APPLICATION NO.	FILING DATE	FIRST NAMED INVENTOR	ATTORNEY DOCKET NO.	CONFIRMATION NO.
10/760,634	01/20/2004	Gregory E. Sancoff	D0188.70165US02	8269
	7590 04/17/200 IFIELD & SACKS, P.0	EXAMINER		
600 ATLANTIC	C AVENUE	YABUT, DIANE D		
BOSTON, MA 02210-2206			ART UNIT	PAPER NUMBER
			3734	
			MAIL DATE	DELIVERY MODE
			04/17/2009	PAPER

Application No.	Applicant(s)				
	10/760,634	SANCOFF ET AL.				
Office Action Summary	Examiner	Art Unit				
	DIANE YABUT	3734				
The MAILING DATE of this communication appears on the cover sheet with the correspondence address Period for Reply						
A SHORTENED STATUTORY PERIOD FOR REPLY IS SET TO EXPIRE 3 MONTH(S) OR THIRTY (30) DAYS, WHICHEVER IS LONGER, FROM THE MAILING DATE OF THIS COMMUNICATION. - Extensions of time may be available under the provisions of 37 CFR 1.136(a). In no event, however, may a reply be timely filed after SIX (6) MONTHS from the mailing date of this communication. - If NO period for reply is specified above, the maximum statutory period will apply and will expire SIX (6) MONTHS from the mailing date of this communication. - Failure to reply within the set or extended period for reply will, by statute, cause the application

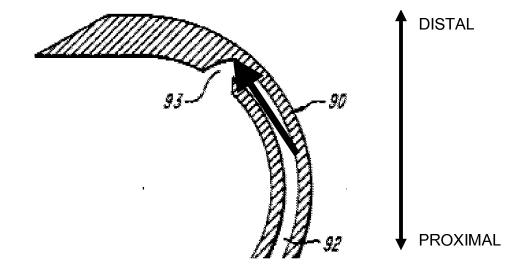
wire axially in the passageway, and a cutter or cutting bar **213** that moves axially along the shaft to cut the suture wire at a location near the distal end of the shaft to free the wire from the instrument. (Figures 1 and 27A-C; col. 7, lines 51-67 and col. 17, lines 1-36). The suture wire extends in a generally distal direction upon exiting the opening, and depending on the type of wire, the wire drive may move the suture wire with force sufficient to penetrate tissue.

Although Makower teaches including or forming a part of the passageway for the suture as seen in Figure 27B, Makower does not expressly disclose the passageway having a curved or "S" shaped portion arranged so that the suture wire moving through and exiting the opening forms suture wire loops

- 5. Applicant's arguments with respect to claims 43-61 have been considered but are moot in view of the new ground(s) of rejection.
- 6. Applicant's arguments filed 08/04/2008 have been fully considered but they are not persuasive.
- 7. Applicant generally argues that Atala does not disclose a suture wire extending substantially in a distal direction upon exiting the opening, but rather a suture wire extending sideways. However, the opening may be considered to be the proximalmost end of **93** or distalmost end of **92** (see annotated Figure 8 below) so upon exiting this section, the wire appears to extending substantially distally.
